## UNION CYCLISTE INTERNATIONALE

### Reminder - New regulations on riders' positions for 2014

Articles 1.3.013 and 1.3.023 of the UCI technical regulations will be amended on 1 January 2014 as indicated in red below:

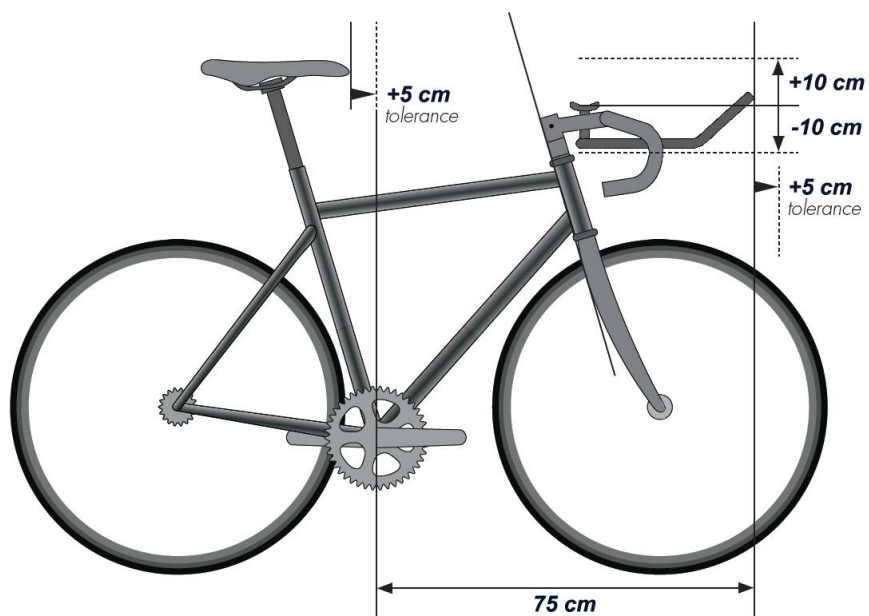
**1.3.013** The peak of the saddle shall be a minimum of 5 cm to the rear of a vertical plane passing through the bottom bracket spindle. This restriction shall not be applied to the bicycle ridden by a rider in a sprint event on track (flying 200 m, flying lap, sprint, team sprint, keirin, 500 metres and 1 kilometre); however, in no circumstances shall the peak of the saddle extend in front of a vertical line passing through the bottom bracket spindle.

The peak of the saddle can be move forward until the vertical line passing through the bottom bracket spindle where that is necessary for morphological reasons. By morphological reasons should be understood everything to do with the size and limb length of the rider.

Any rider who, for these reasons, considers that he needs to use a bicycle of lesser dimensions than those given shall inform the commissaires' panel to that effect **at the time of the bike check** ~~when presenting his licence. In that case, the panel may conduct the following test. Using a plumb line, they shall check to see whether, when pedalling, the point of the rider's knee when at its foremost position shall not pass beyond a vertical line passing through the pedal spindle (see diagram «Measurements (2)»).~~

**Only one exemption for morphological reasons may be requested; either the peak of the saddle can be moved forward or the handlebar extensions can be moved forward, in accordance with Article 1.3.023.**
